**HISTORIC PRESERVATION REVIEW BOARD
STAFF REPORT AND RECOMMENDATION**

Landmark/District: **Anacostia Historic District** (x) Agenda
Address: **2221-2225 Chester Street SE** (x) Concept

Meeting Date: **September 18, 2014** (x) New construction
Case Number: **14-613**
Staff Reviewer: **Tim Dennée**

The applicant, owner District Properties (Mohamed Sikder), requests the Board's review of a conceptual application to construct two semi-detached two-story frame houses on two adjoining vacant lots.

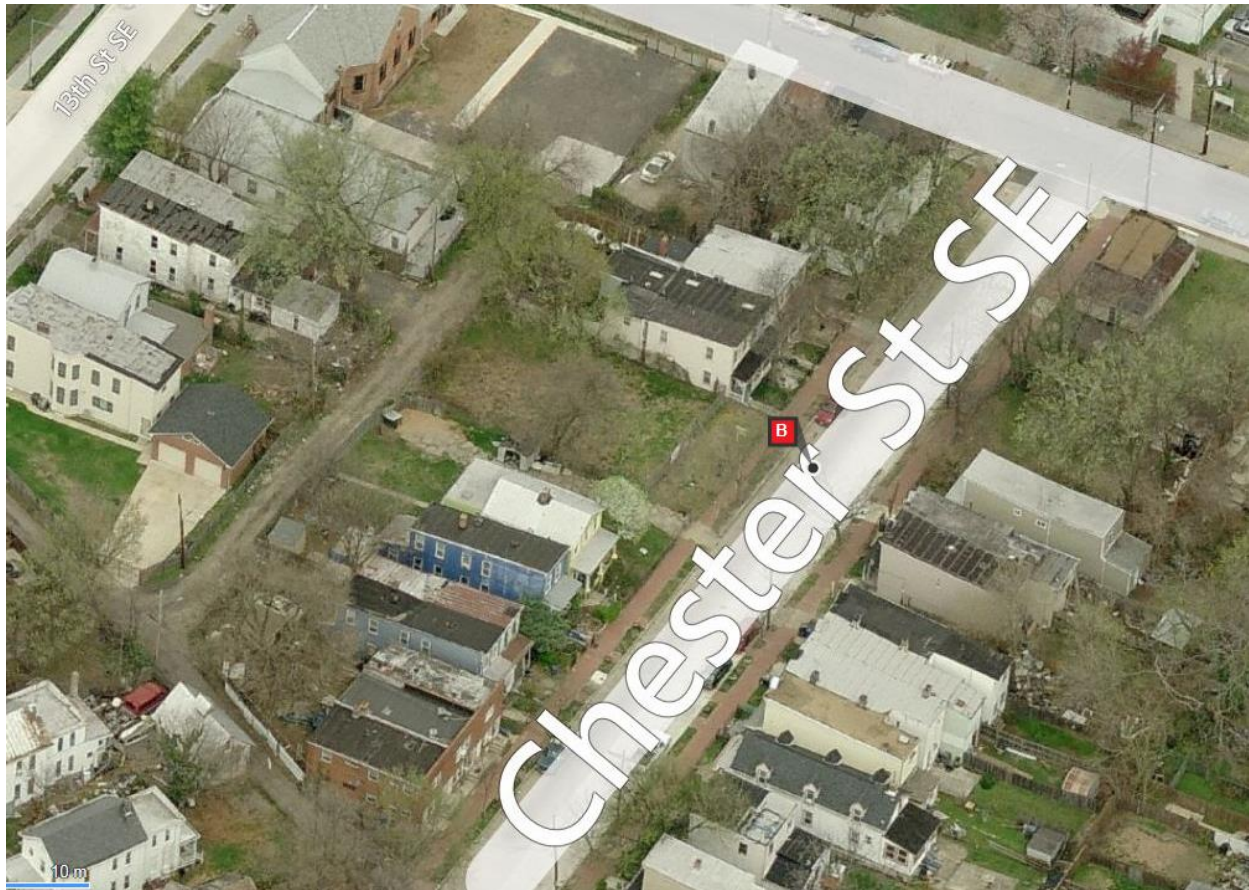
In October of last year, the Board approved the applicant's concept for a single two-story house at 2221 Chester Street (see drawing below and staff report attached), but its design has changed, in addition to being joined by, and to, a second building. The earlier staff report is attached, as it discusses the compatibility issues in more detail.
